Field Problem Reports

Model(s):
DVPS560D

Subject: No part number listed for IC101
Symptom:
Last Update: 2001-05-08
Status: Closed

Model: DVP-S360, DVP-S560D, DVP-S570D, DVP-C660, DVP-C670D **No. 68**

MB-87 Board (Side B)

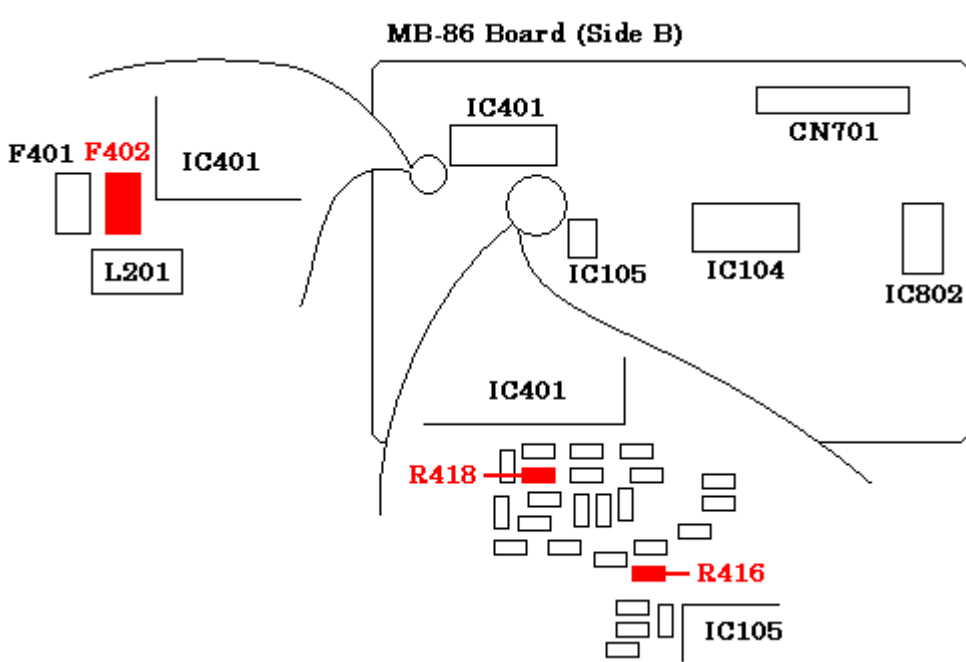
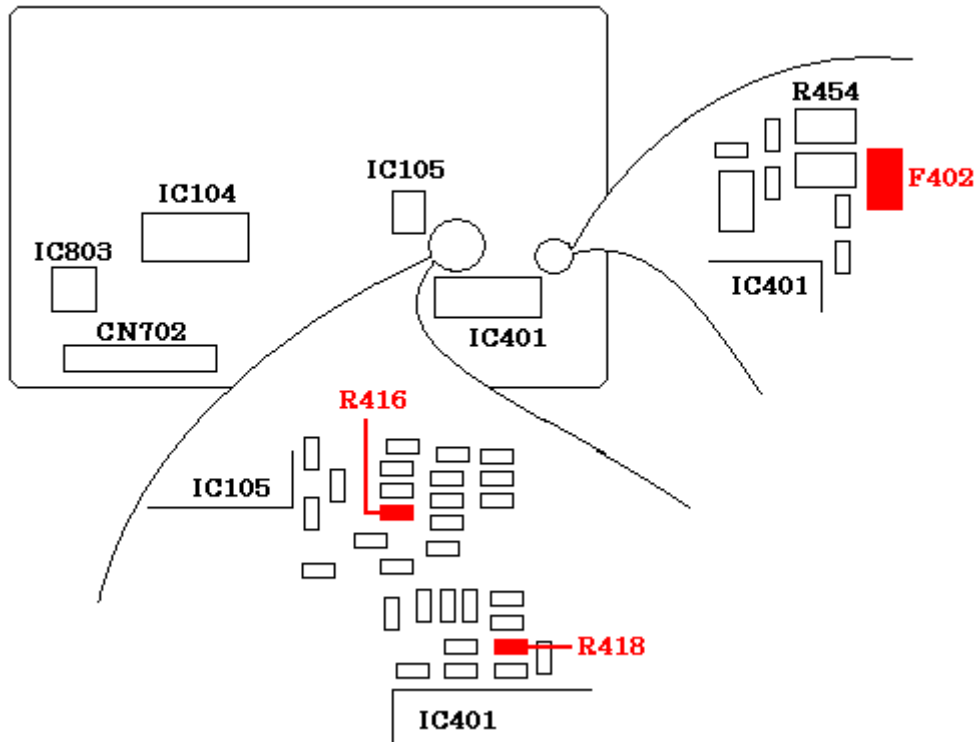
Symptom:
(111A) The DVD player may not play disc. The display may indicate "No Disc "or C:13:00"

Solution: Please remove fuse F402 and replace with 0-ohm resistor on MB board (side B). Next, exchange resistors R416 and R418. The original values are 150K, change them both to 82K ohms

REF	DESCRIPTION	PART NUMBER
F402	CONDUCTOR, CHIP(2012) METL RES 0H 1/10W	1-216-295-11
R416/ R418	RESISTOR,CHIP 82K 1/16W	1-216-844-11

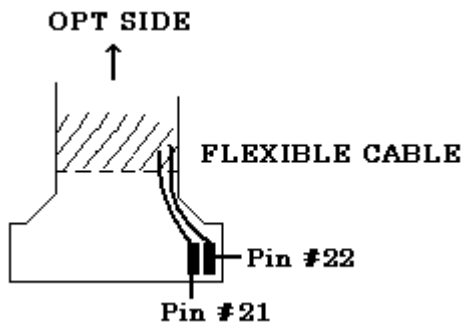
3. Measure the resistor between Pin # 21 & Pin # 22 of the Flexible Cable, which is connected with the OPT. (See the figure below.) If the resistor between Pin # 21 & Pin # 22 is below 6 ohms, replace the OPT to the new one.
